5556/5558 South Sycamore Sketch Plan Appeal

Resolution 38-2018

Sketch Plan

SYCAMORE DUPLEX 1
5556/5558 S. SYCAMORE ST.
Case No. SP18-0011
(Related Case No. PDO16-001, SDP15-0013)

Re: 5556 & 5558 S. Sycamore St.
Littleton, CO 80120
SDP15-0013

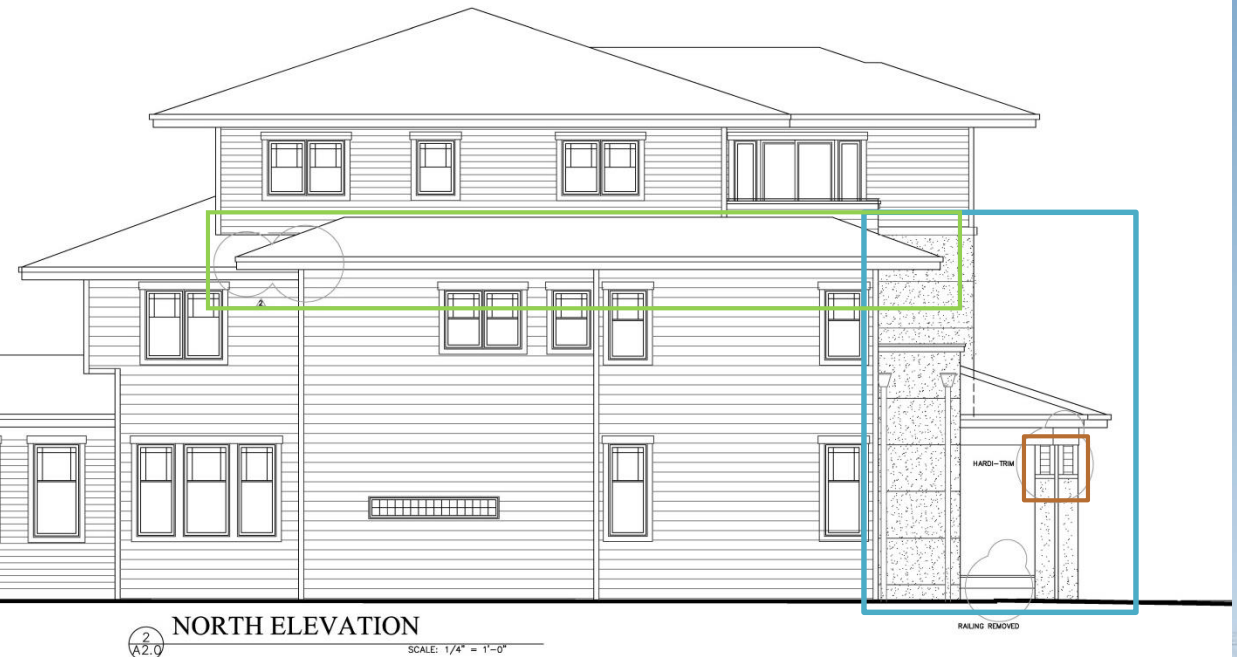
1. Replace siding material from Travertine Tile to Stucco

Intent: Place a Travertine colored smooth stucco in place of large (24x48) Travertine tile on front elevation. Reason for change: We found builders who have tried this application found the tile tends to discolor and because of freeze and thaw the tile falls off the wall, creating a safety concern as well as an unsightly problem. Remove rail at front of porch as it is less than 12" above grade, therefore not required by code. This look is also much more inviting from the street.

A2.1

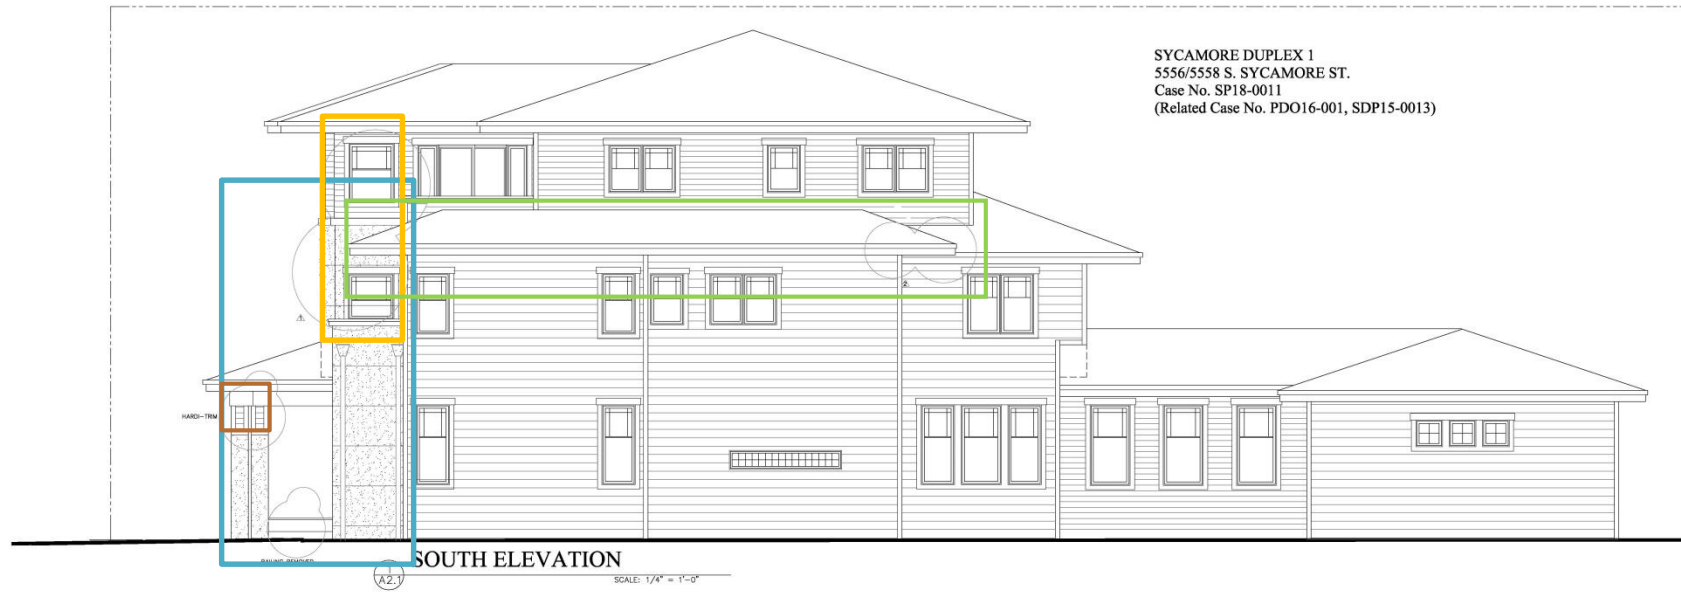
1. Replace siding material from Travertine Tile to Stucco

3. Modify design of front columns

4. Modify corner window on west/south elevation

5. Modify the middle eave on the north and south elevations by 9"

Modify Columns

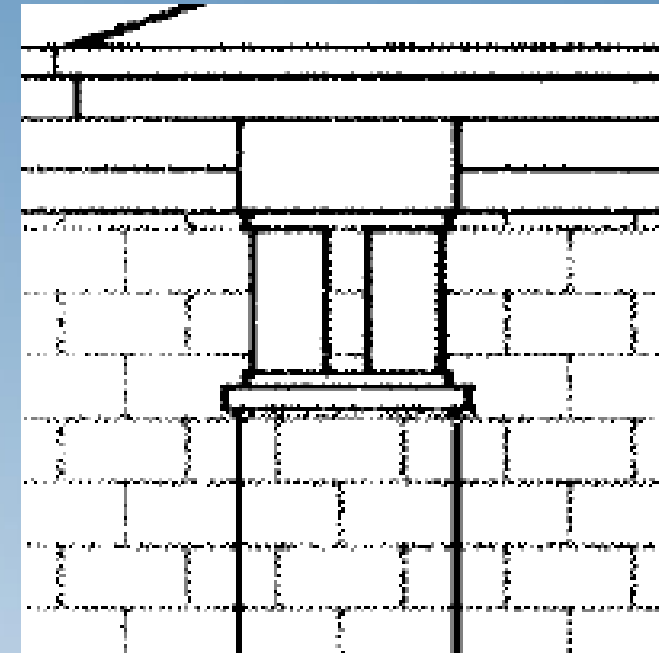
3. Modify design of front columns

Modify Corner Window

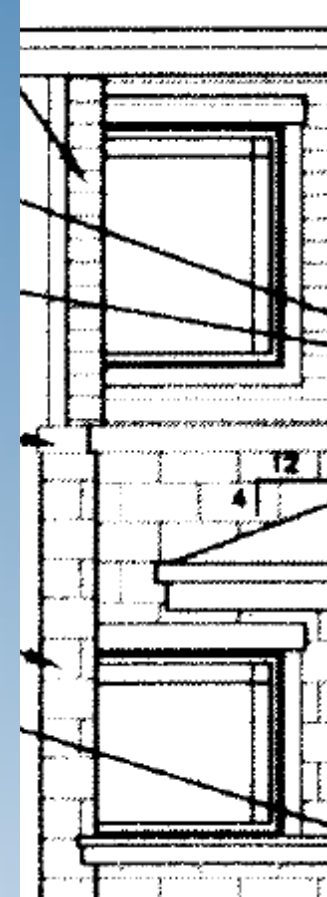
4. Modify corner window on west/south elevation

Window, Column, Railing

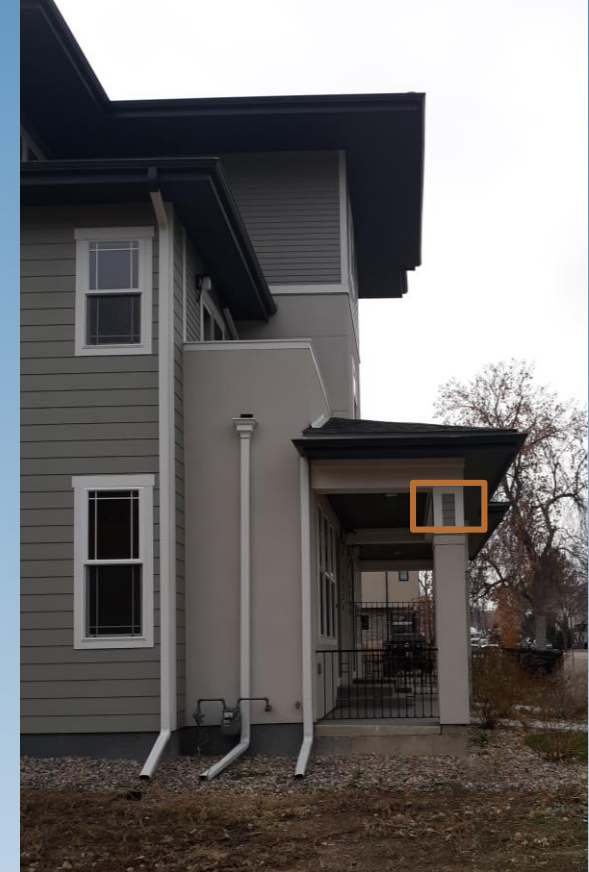
2. Remove front railing on porch

3. Modify design of front columns

4. Modify corner window on west/south elevation

Modified Roof Plan

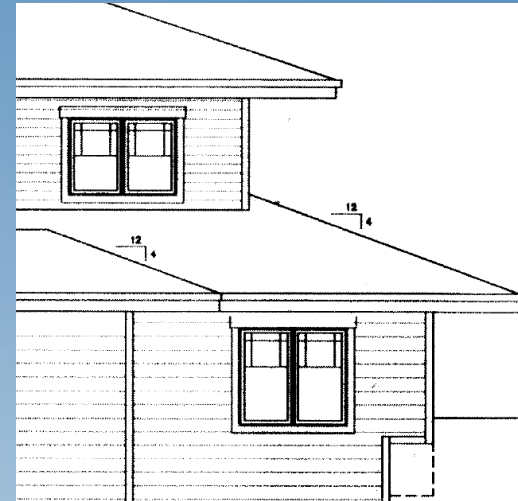
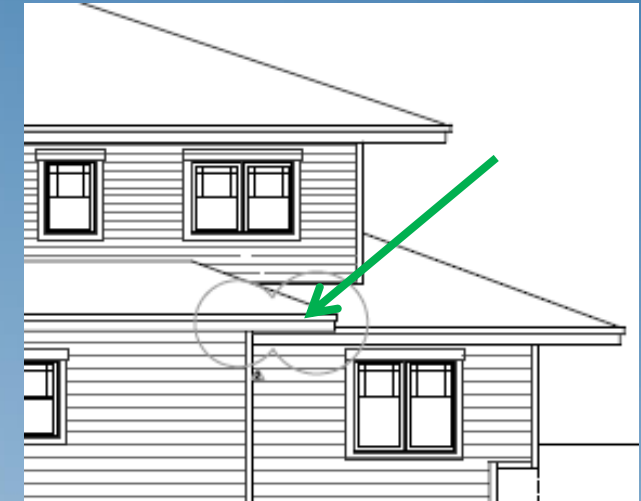
5. Modify the middle eave on the north and south elevations by 9"
